## CITY OF GLENDALE, CA

### ADMINISTRATIVE DESIGN REVIEW STAFF REPORT – MULTI-FAMILY

<b>November 18, 2021</b> <i>Decision Date</i>	<b>1037 Ruberta Avenue</b> <i>Address</i>
<b>Administrative Design Review (ADR)</b> <i>Review Type</i>	<b>5623-027-013</b> <i>APN</i>
<b>PDR2115117</b> <i>Case Number</i>	<b>Louis Romero</b> <i>Applicant</i>
<b>Minjee Hahm</b> <i>Case Planner</i>	<b>Vartan Bursalyan</b> <i>Owner</i>

The applicant is proposing to demolish an existing 1,010 square-foot (SF) dwelling (built in 1925) with a detached, one-car garage and construct two detached dwelling units (1,765 square-feet and 1,746 square-feet respectively) with attached two-car garages on a 7,275 square-foot lot, located in the R-2250 (Medium Density Residential) Zone.

A3.2

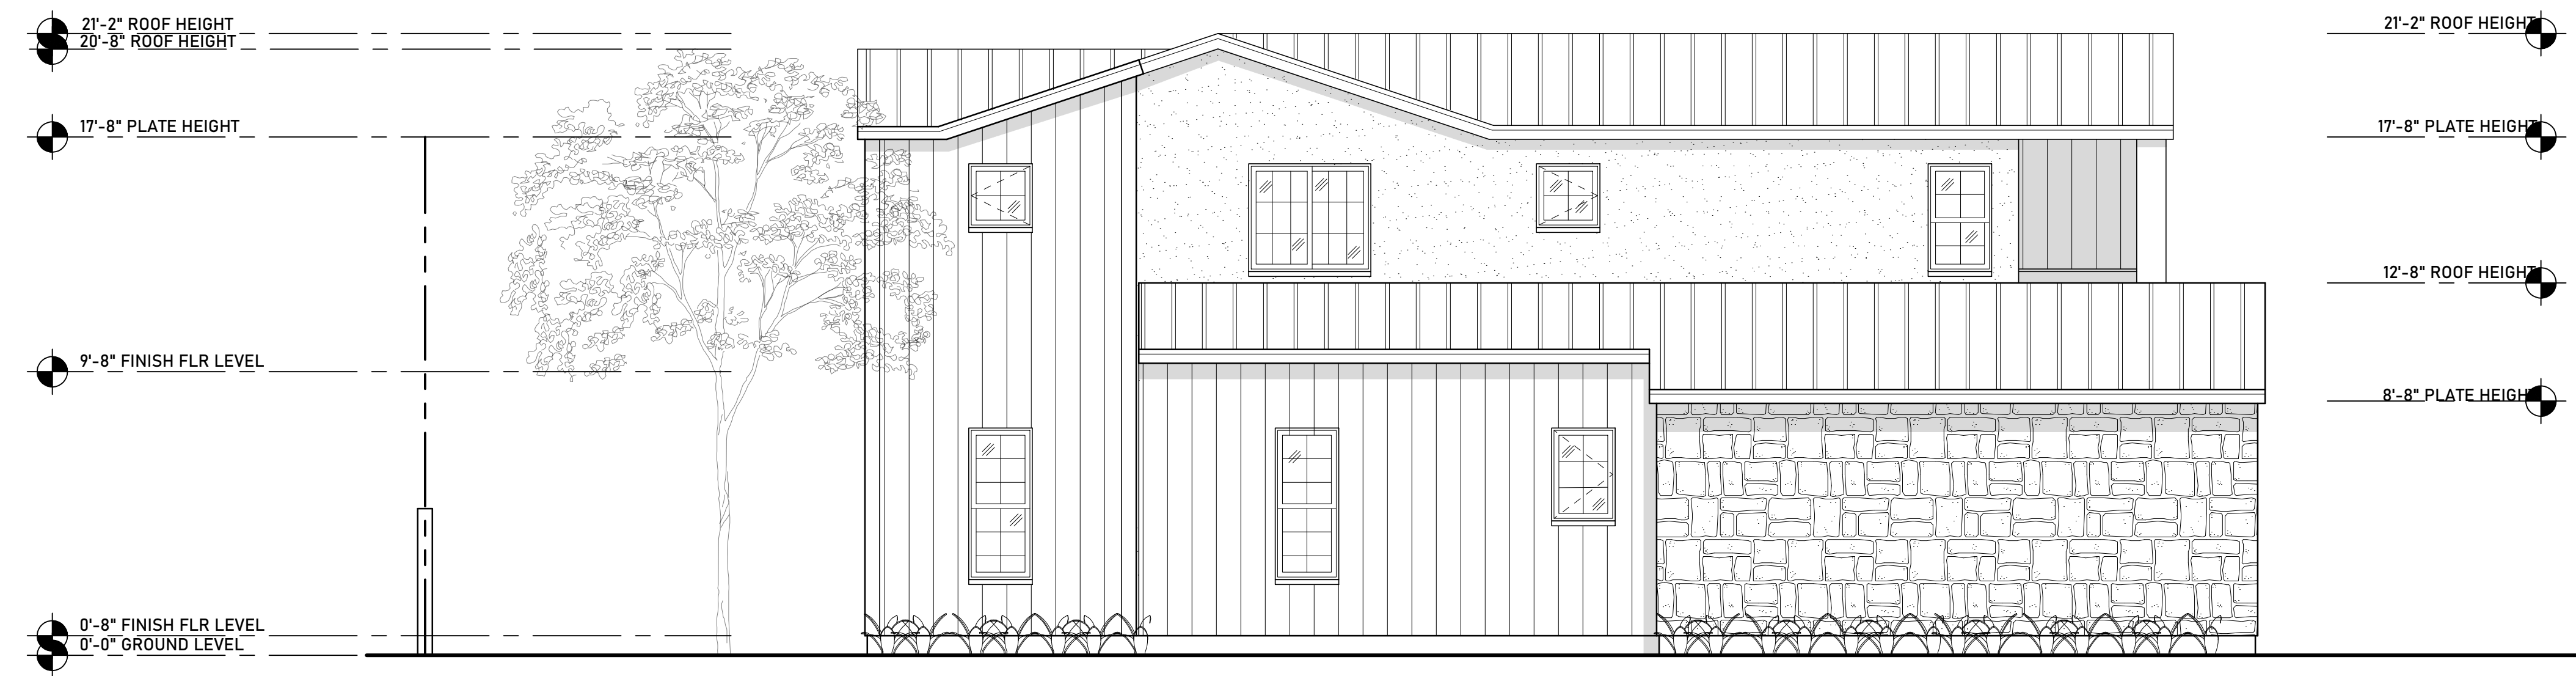
- The proposed materials include grey standing seam metal roof, grey manufactured stone veneer, light-colored stucco, and light-colored cement vertical siding, which are suitable for the proposed design. Because the proposed material board lacks information for other materials that are shown on elevations and renderings, a

condition is included requiring the applicant to provide information for all proposed materials.

WINDOW SECTION

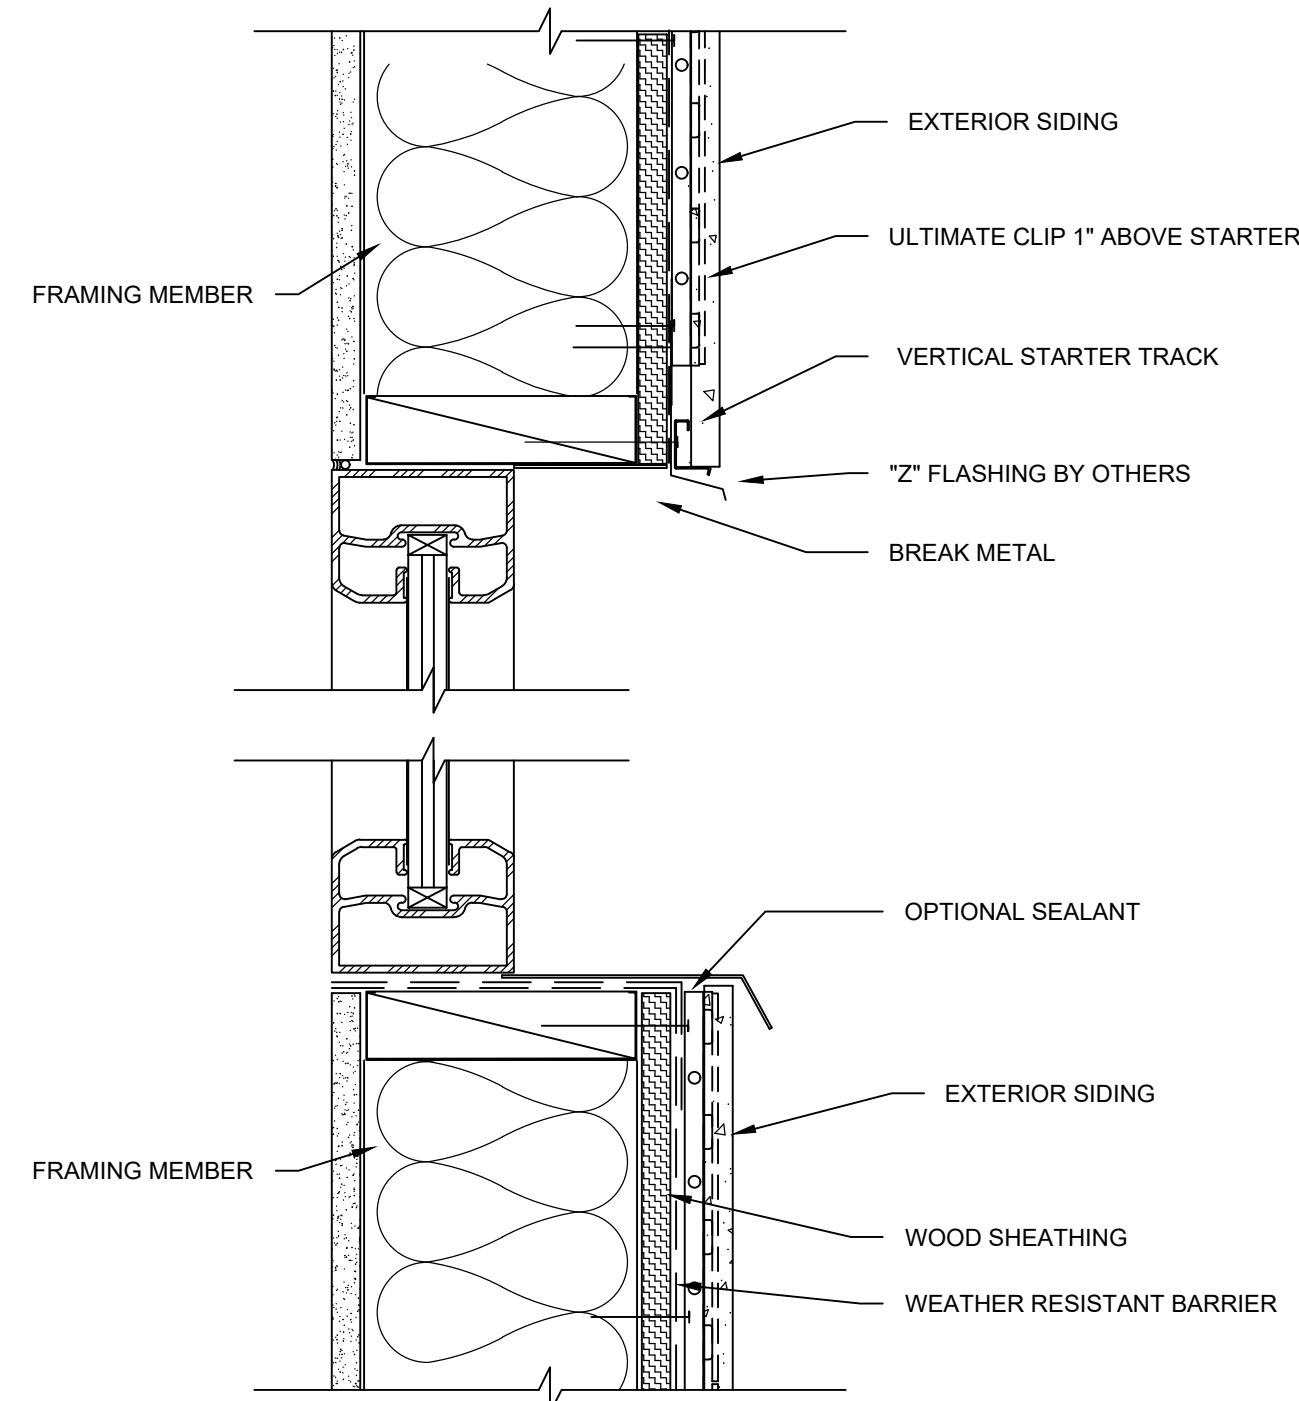
The new windows will have black fiberglass frames with combination of casement, fixed, sliding, and single hung operations with external grids. The windows are complementary to the style of the new dwellings and will be recessed with new sills and trim. Overall, the proposed windows on the building are appropriate for the design of the new units. However, a condition is added requiring that the provided vertical window section detail be revised to clearly show the new sills and trim, as shown on elevations and renderings. In addition, the proposed window grid pattern is inconsistent, showing vertical, horizontal, and square patterns. A condition is included requiring the applicant to restudy the window sizes for more consistency and to provide revised drawings for staff review and approval prior to submittal.

1. Clarify that the posts/gate are located behind building façade of Unit A.
2. Revise vertical window section detail to show sills and trim.
3. Restudy window grid patterns and provide revised drawings for staff review prior to submittal.
4. Provide information and details for: proposed railings, gate, driveway gate, posts, light fixtures on the material board or provide call-outs for all exterior material on elevations.
5. Exterior cladding material to wrap at interior corners of Unit A on north and east elevations.
